Planning Commission Staff Report

Case No.: PA-09-001

Application Type: Pre-Application

Location: 123 North Palm Canyon Drive

center street cross section
scale = 3/16" = 1'-0"

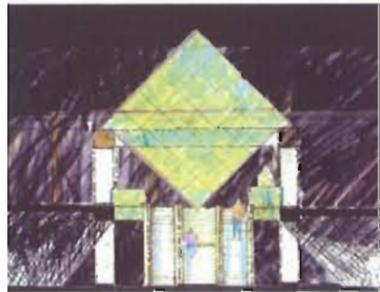
- Installation of additional fire hydrants will be needed on the center street.
- Fire apparatus access road on the center street to be designed, and maintained to support the imposed loads of fire apparatus (73,000 lbs. GVW) and shall be surfaced so as to provide all-weather driving capabilities.

- Fire apparatus access road on the center street to have a minimum unobstructed width of 24 feet.
- Fire apparatus access road on the center street to have a minimum unobstructed width of 26 feet in the immediate vicinity of any building or portion of building more than 30 feet in height.

- Proposed canopy along the center street presents an obstruction for ground ladder and aerial ladder operations.

cross section thru escalators
scale = 1/8" = 1'-0"

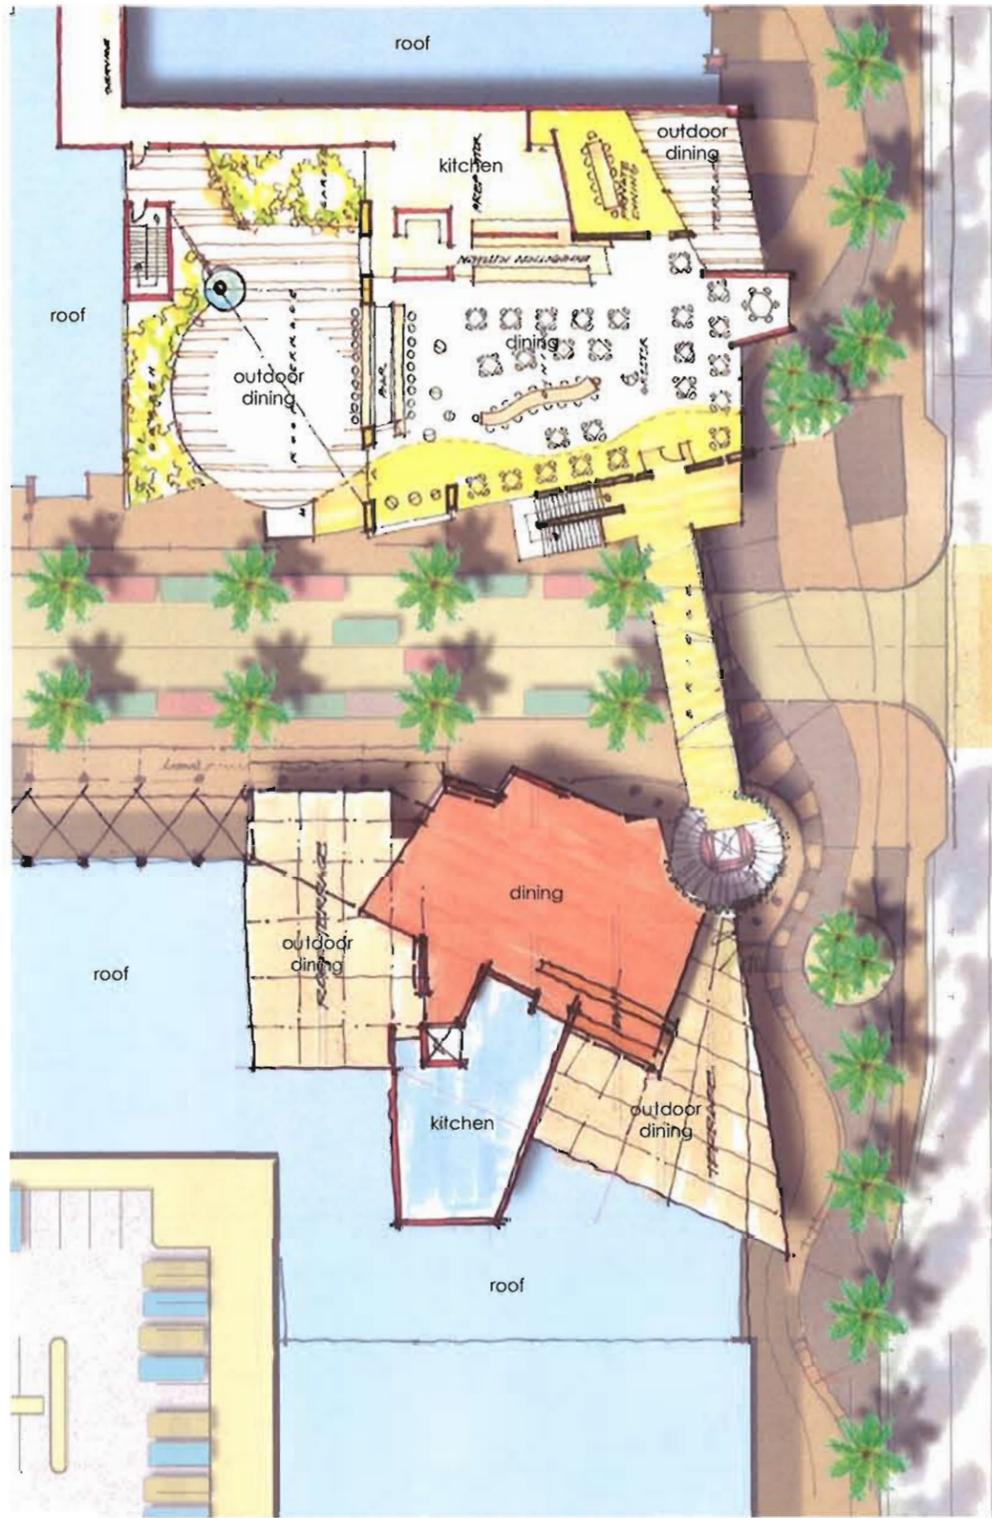
- An unobstructed vertical clearance of not less than 13 feet 6 inches is required for fire apparatus access under the foot bridge. Current drawings show 19' vertical clearance under the foot bridge.
